12-026.10 • Lakehead University • Moksha Yoga Assemblies and Plan

**12-026.10 • Lakehead University • Moksha Yoga
Cross Section Scale 1/4"=1'-0"**

MOKSHA YOGA STUDIO
LAKEHEAD UNIVERSITY

DESCRIPTION OF PROJECT: Moksha Hot Yoga Renovations

1 Assemblies
1 : 10

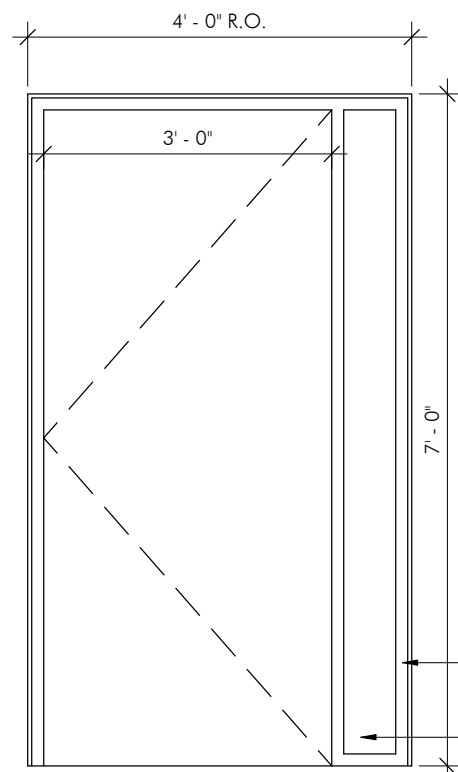
Q5: Should the 2 inch by 2 inch wood furring in the *P1 – Interior Wall Assembly* be installed at 16 inch O.C?

A5: No. See attached drawing A1- Assemblies and Plan - Rev 1 - Dec 1 2014 for changes to *P1 – Interior Wall Assembly*.

<p>P1 - Interior Wall Assembly</p> <ol style="list-style-type: none"> 5/8" Drywall 6 mil AVB 1.5" Rigid Insulation w/ 2x2 wood furring at 2' o/c <p>*Provide blocking for fastening of mirrors and ballet bar.</p>
	<p>C1 - Interior Ceiling Assembly</p> <ol style="list-style-type: none"> Existing metal deck and OWSJ R40 spray foam insulation w/ thermal barrier. <p>-Walltite Eco - Spray Polyurethane Foam Insulation / Air Barrier (or approved equal).</p> <p>-AD Cementitious Thermal Barrier (or approved equal), 22m thick. Suitable for exposure in supply and return air ceiling conditions</p> <ol style="list-style-type: none"> Provide 1" coverage to OWSJ webs, see detail A5/2

2 Entry Door
1/2" = 1'-0"

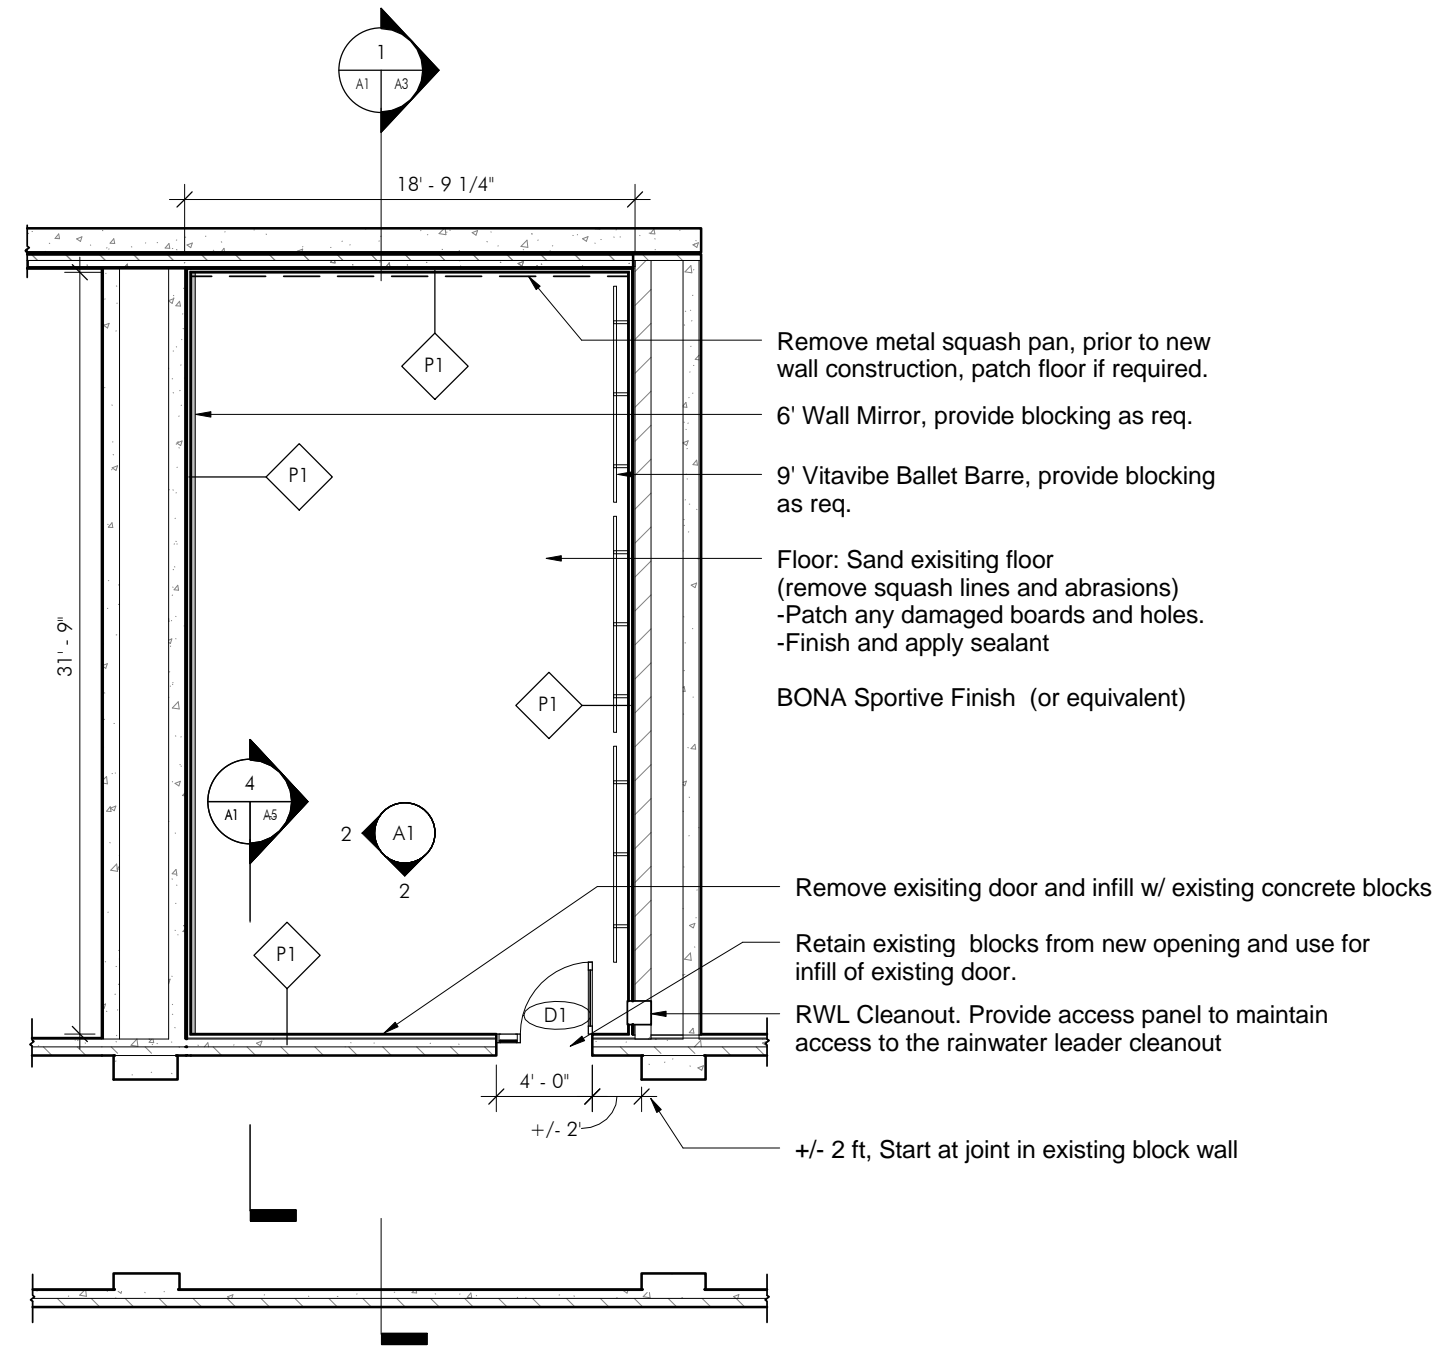
Q9: Should the entry door with opaque sidelight be a 36 inch door?

Q10: What material should be used for the solid infill panel on the entry door with opaque sidelight?

A9: Yes. See attached drawing A1- Assemblies and Plan - Rev 1 - Dec 1 2014.

A10: The solid infill panel will be metal and painted to patch door frame. See attached drawing A1- Assemblies and Plan - Rev 1 - Dec 1 2014.

PAINT FRAME AND STEEL LINTEL ABOVE (CONSULTANT TO PROVIDE COLOUR)
SOLID METAL INFILL PANEL PAINTED TO MATCH FRAME

① MECH. RM. ROOF FRAMING PLAN
1/8" = 1'-0"

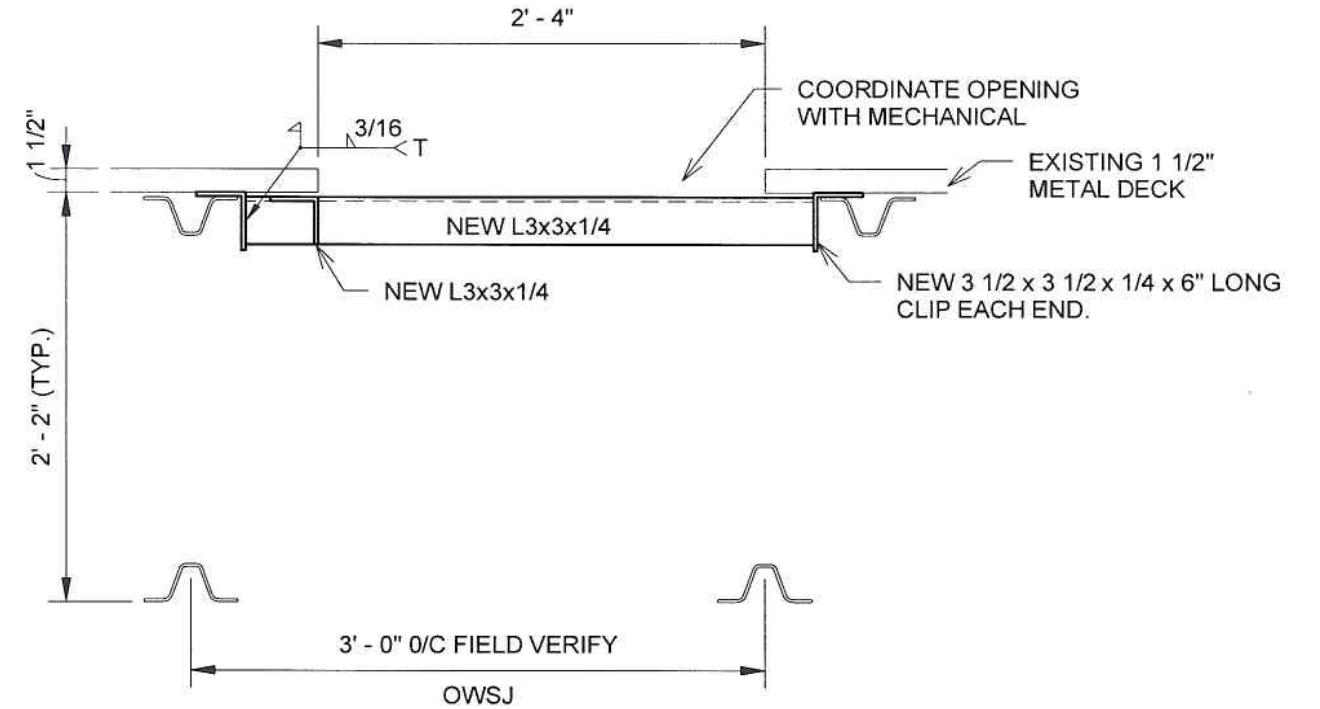
Q3: On detail 2 drawing M2 there is a note to refer to structural for the new roof opening. There are no structural details for the roof on S01 drawing.

A3: The structural roof framing requirements are on shown on Drawing 14-1829-003_S02_Rev 0 (attached).
